TEXAS UTILITIES GENERATING COMPANY

COMANCHE PEAK STEAM ELECTRIC STATION
Independent Assessment Program Phase 3
Cinched U-Bolt Testing & Analyses Program
Additional Information

ATTACHMENT 1

Revision to Item 2 of Reference 1.

FIGURE 1

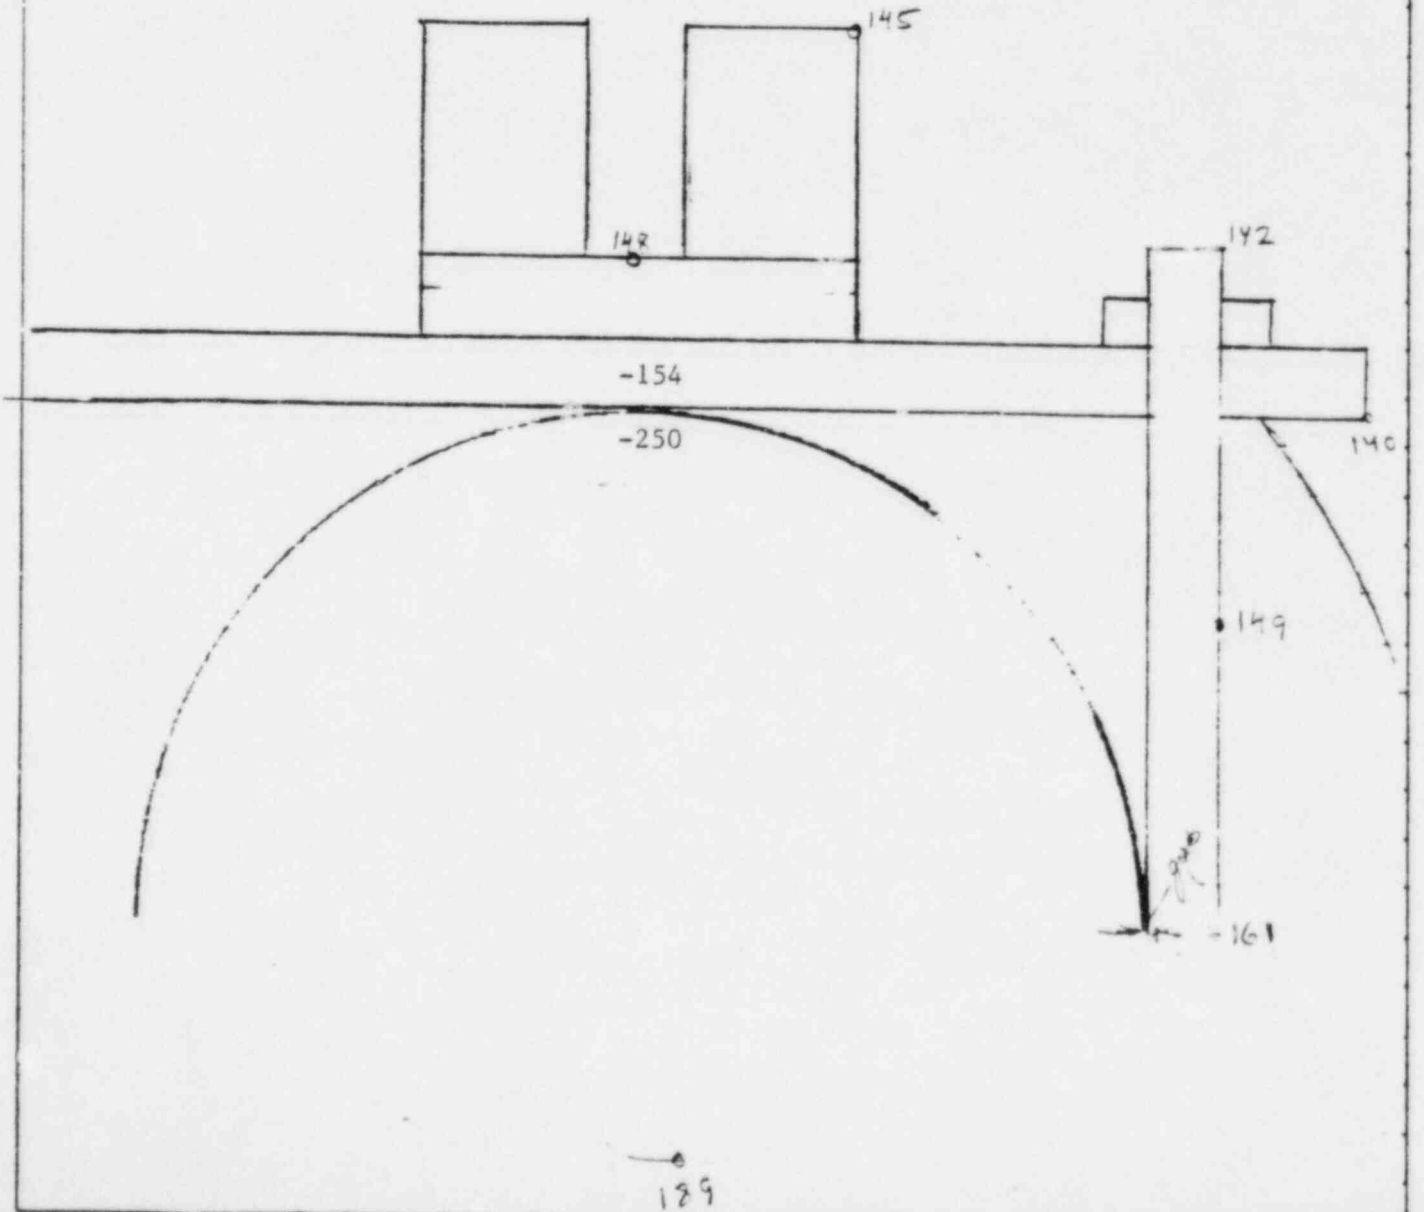
Results of finite difference thermal analyses are very sensitive to the assumed area of contact between the pipe and the U-bolt and the pipe and the crosspiece. When the U-bolt is cinched, the line contact between the pipe and the U-bolt extends for an arc which is less than 180°, and the precise extent of which depends on the cinching force and the spacing of the bolt holes in the crosspiece. Similarly the cinching process tends to produce a loss of contact at some points between the crosspiece and the pipe due to either bending of the crosspiece or local deformation of the pipe. This loss of contact, however small, profoundly affects the heat transferred from the pipe to the crosspiece.

A heat transfer model has been executed for the uninsulated U-bolt configuration with the following assumptions. Heat transfer from the pipe to the U-bolt is along an arc near the apex of the U-bolt. At the diametral location there is a small gap (less than 1/16") between the pipe and U-bolt. No gaps are assumed between the U-bolt and the crosspiece (the assumption is believed to be inconsequential since both elements are roughly at the same temperature at that location). Heat transfer between the pipe and the crosspiece takes place through a line contact extending 2 inches along the pipe, and via gap conductance, along the circumference of the pipe and through a gap increasing from zero to 1/128" linearly from the end of the contact area to the end of the plate. Likewise, the heat transfer between the pipe and the U-bolt also considers the gap conductance with areas immediately adjacent to the line of contact and extending out to the U-bolt radius. This model produced results which more closely match the results of the test.

Results of the analyses are shown in Figure 1 for the uninsulated case. In Figure 2 similar results are shown for the insulated case. The only difference between the latter analyses and that of the uninsulated configuration are the pipe temperature, which in the latter instance is 350°F, and the presence of insulation.

For the uninsulated case the average temperature of the U-bolt in the curved portion is 175-180°F, while the straight portion is at about 150°F. For the insulated case the corresponding temperatures are approximately 300°F and 260°F respectively.

FIGURE 3

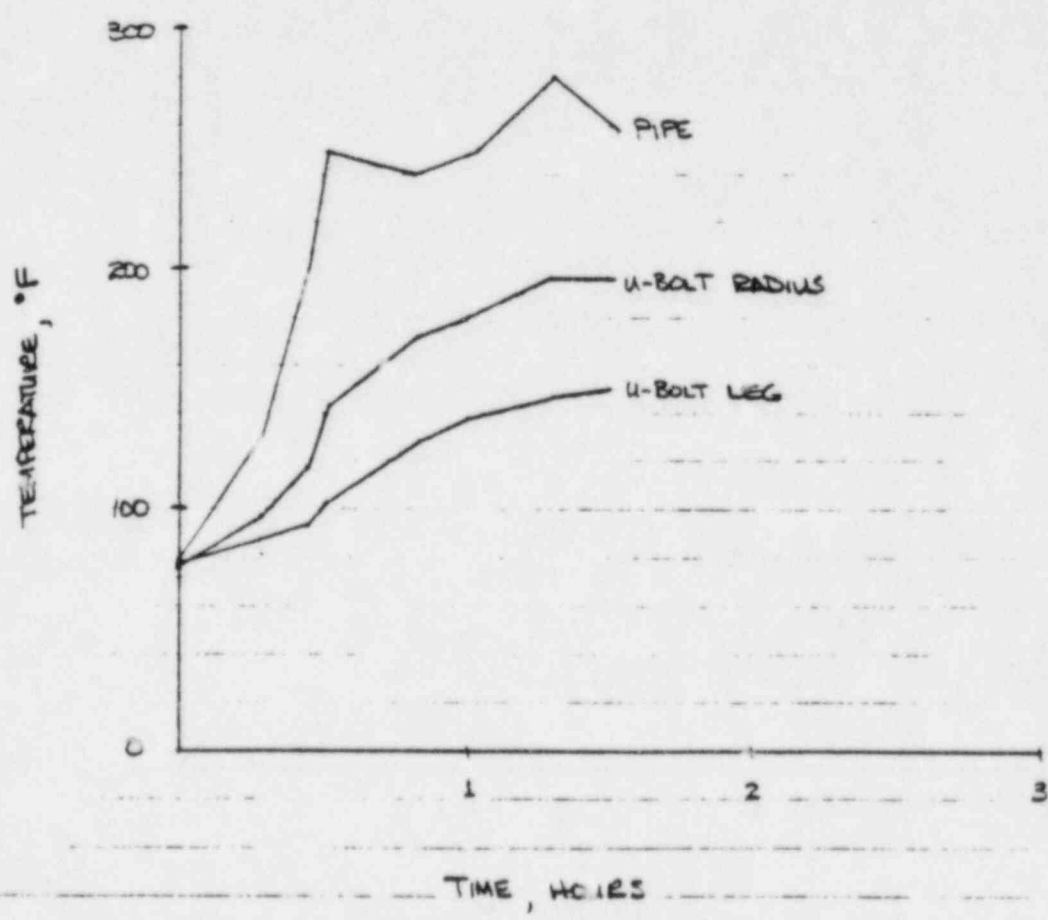
The pipe reached the test temperature of 250°F at 30 minutes, but then continued to climb to over 280°F before settling back down at 258°F. The U-bolt radius and leg stabilized around 195°F and 150°F, respectively, near the end of the cycle. See Figure 3.

Another point to be discussed, is that the test has provided information on the transient thermal expansion differential between the pipe and the U-bolt. As seen from the data which is attached as Figures 3 and 5, the maximum temperature differential between the pipe and the U-bolt occurred when the U-bolt has reached a representative temperature of about 100-105° while the pipe had been heated to 250-255°, a difference in temperature of approximately 150°F. This difference is well simulated in the finite element analysis where there is a constant difference in temperature of 140°F. It should also be remembered that for these temperature differentials, the amount of stress caused by the thermal expansion is not very significant.

FIGURE 4

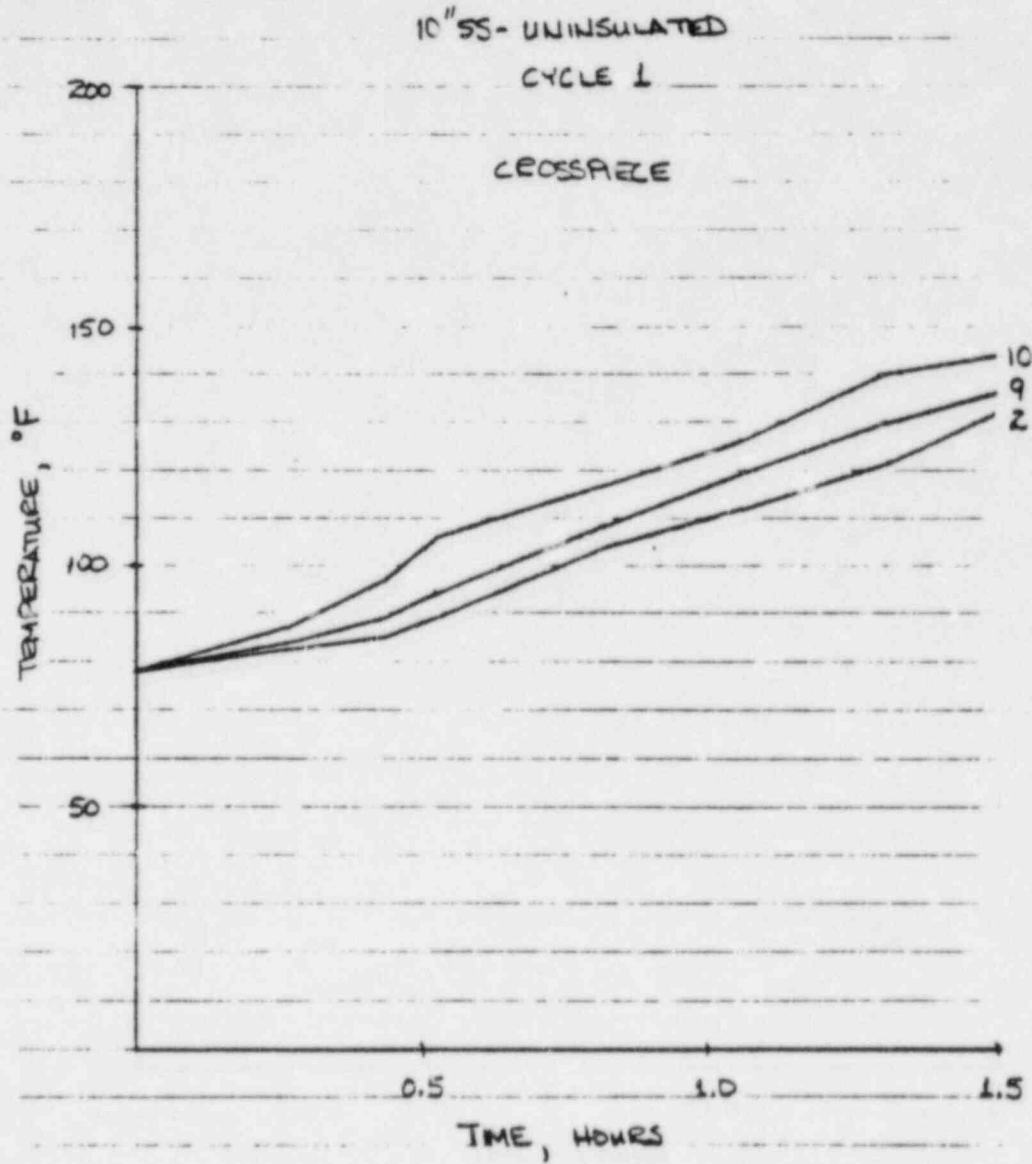
Thermocouples 2, 9 and 10 on the crosspiece reached temperatures of 129°F, 136°F and 144°F, respectively, at the end of Cycle 1. These are less than the equilibrium temperatures reached during the creep test. Figure 4 shows that temperatures had not leveled off. Refer to Figure 9 for location of thermocouples.

FIGURE 5

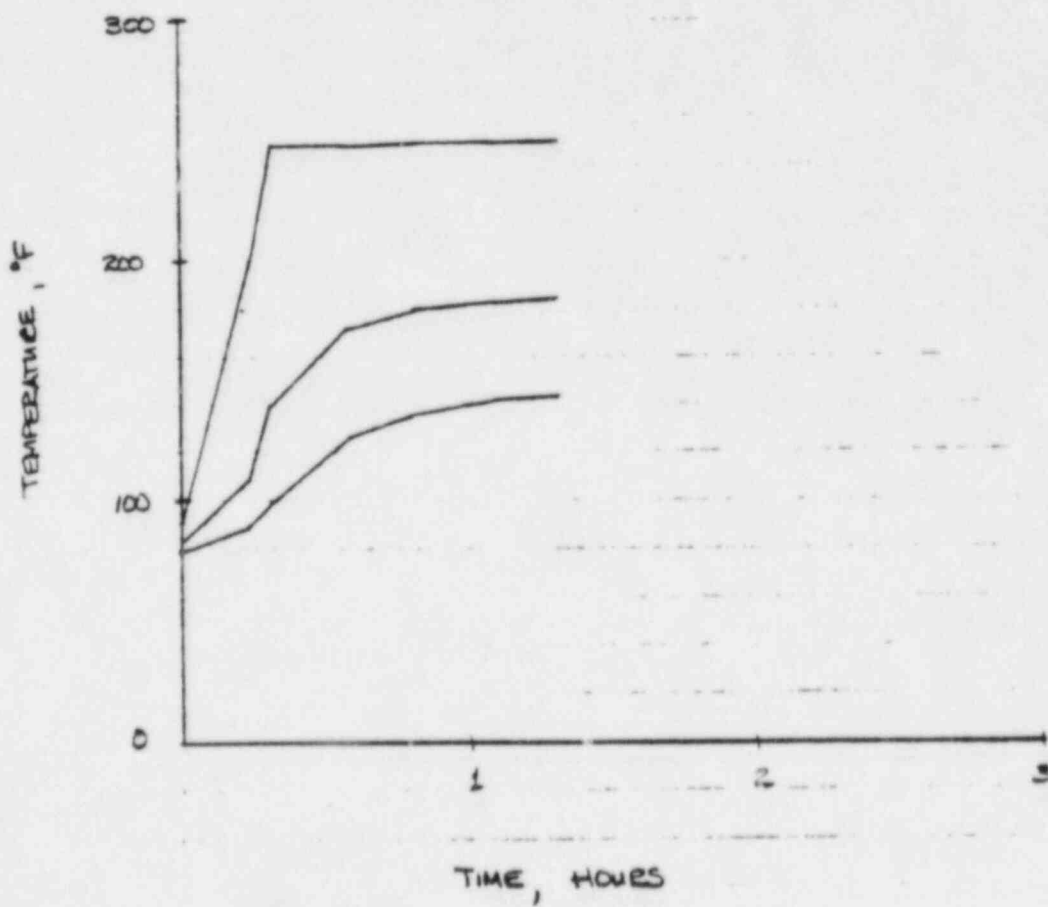
The pipe reached an equilibrium temperature of 250°F within 20 minutes. The U-bolt radius and leg reached 183°F and 144°F, respectively, around 1 hour. See Figure 5.

FIGURE 6

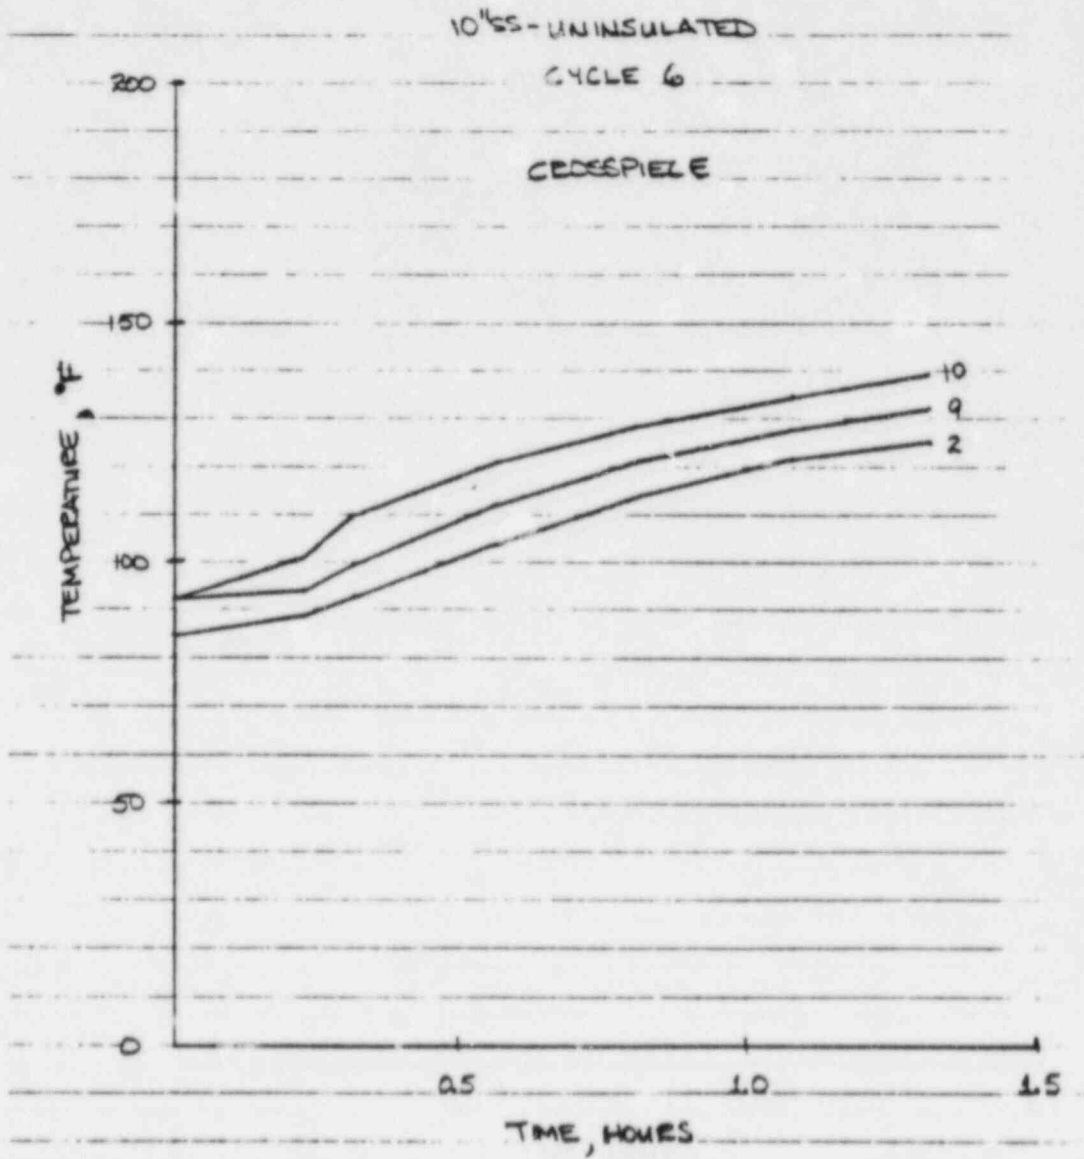
Thermocouples 2, 9 and 10 on the crosspiece reached temperatures of 125°F, 132°F and 139°F, respectively, at the end of Cycle 6. These are less than the equilibrium temperatures reached during the creep test. Figure 6 shows that temperatures had not leveled off.

FIGURE 7

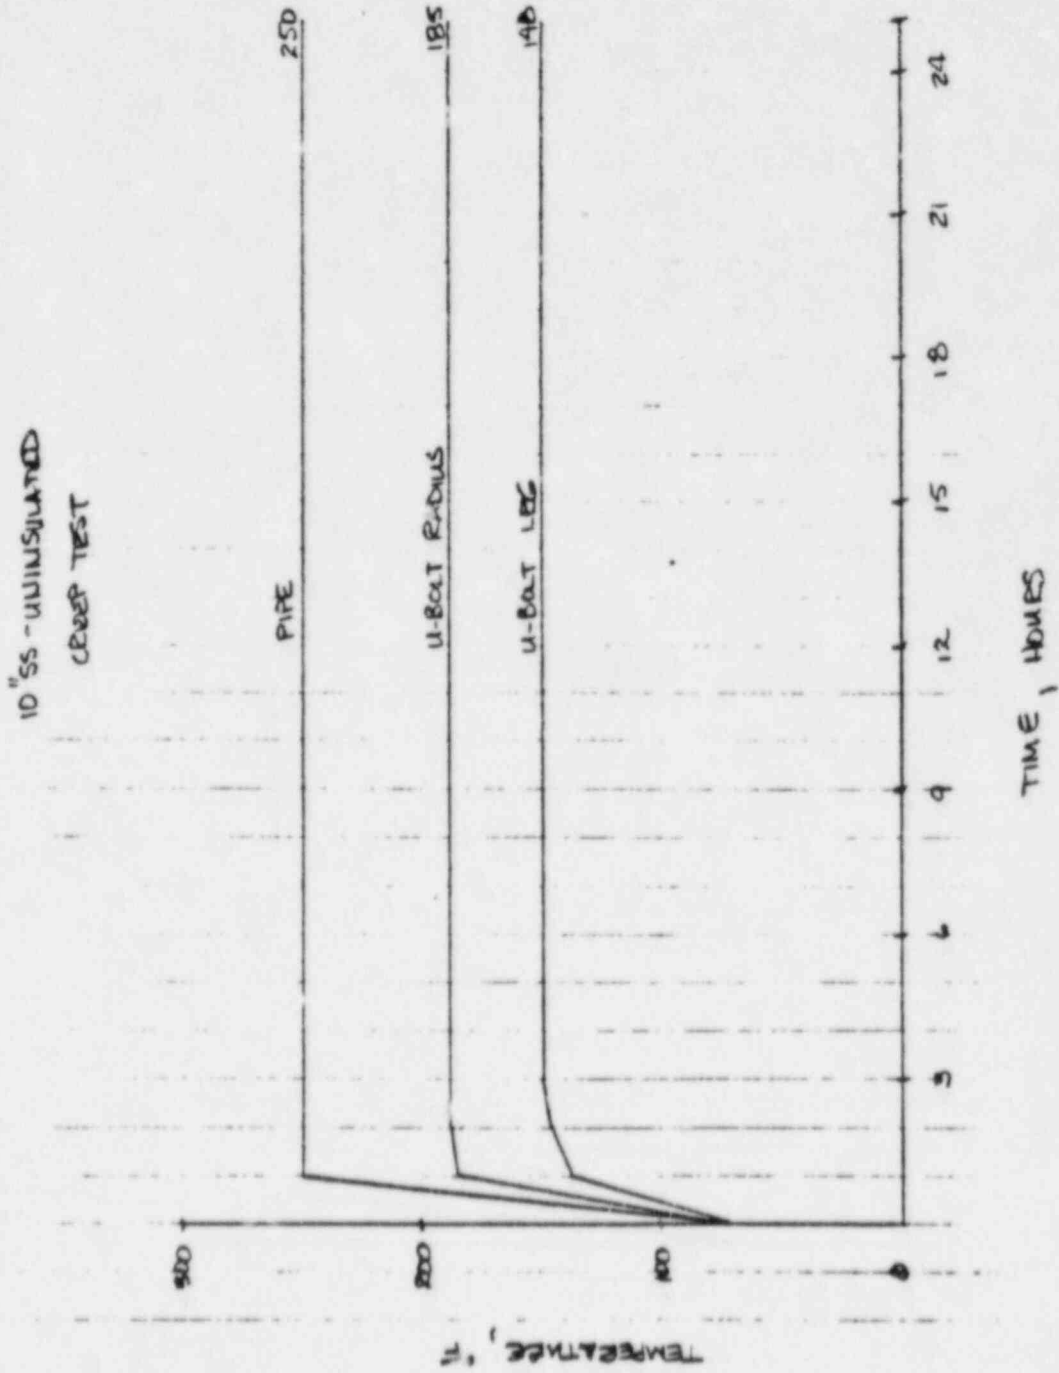
The pipe reached an equilibrium temperature of 250°F in less than 1 hour. The U-bolt radius stabilized at 185°F within 1 hour. The U-bolt leg stabilized at 148°F within 2 hours. See Figure 7.

FIGURE 8

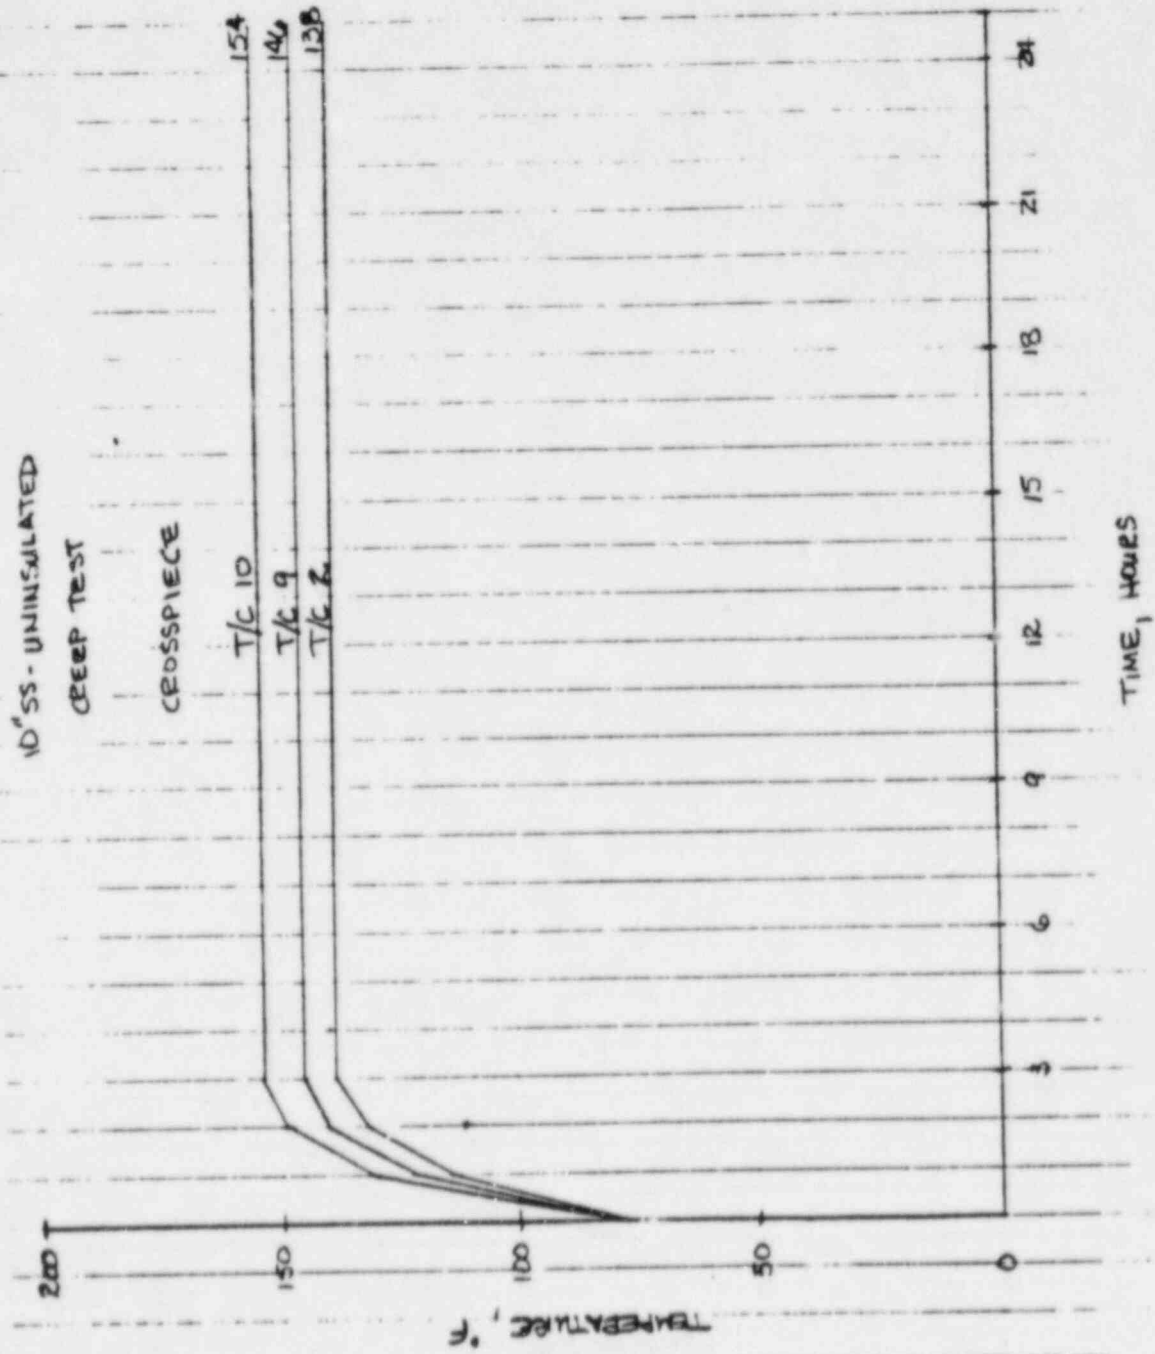
Thermocouples 2, 9 and 10 on the crosspiece reached equilibrium temperatures of 138°F, 146°F and 154°F, respectively, around 3 hours. See Figure 8.
